INDEPENDENT ADVISORY PANEL FOR UNDERGROUND MINING

DENDROBIUM EXTENSION PROJECT

SSI-33143123

July 2022

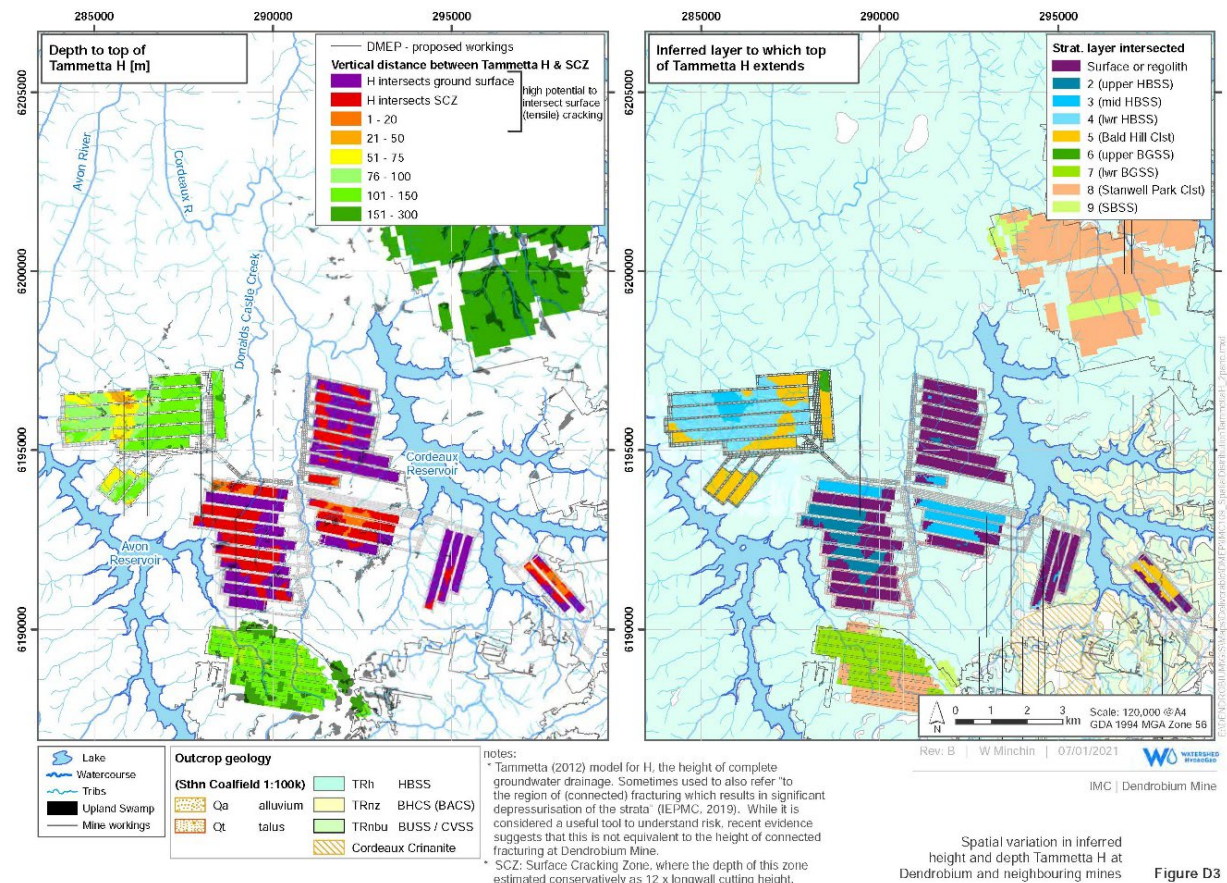
The following figure extracted from the Groundwater Study (Appendix B of the EIS) shows the predicted height of complete groundwater drainage based on the Tammetta Equation.

- Can IMC please provide a suite of figures based on the above figure for longwall panel widths of 150 m, 200 m, 250 m and 305 m and which, additionally, include figures showing the upper and lower bounds (error bands) of predictions based on the Tammetta equation.

Fig. 3.14 Proportion of pools with Type 3 impacts along Drainage Line WC21 in Area 3B

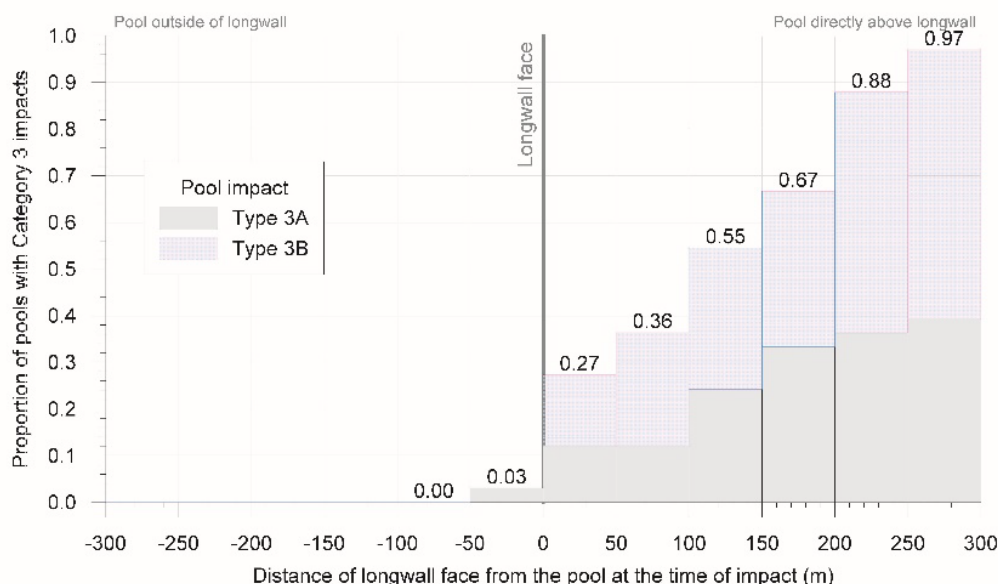
- iv. The figures quoted in the text under the above figure for the percentage of pools experiencing Type 3B impacts appear from the graphic to also include Type 3A impacts; that is, the quoted percentages appear in the graph to be made up of both Type 3A and Type 3B impacts. Please clarify.
- v. Can IMC please provide a tabulation comparing the predictions based on the previous rock bar model with those based on the revised model for the circumstances associated with the revised mine plan for the DME?

Figure 5: Risk Criteria "ALARP"

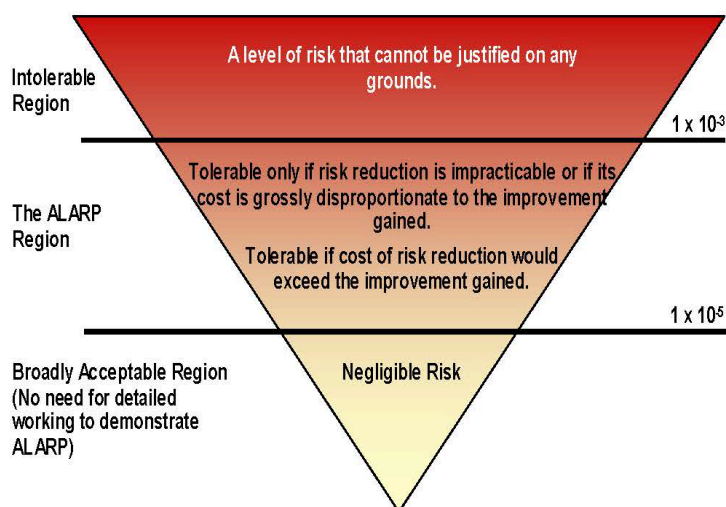
- ix. What do the values ' 1×10^{-3} ' and ' 1×10^{-5} ' correspond to in the above figure?
- x. How do these values relate to ALARP in the preceding risk matrix?
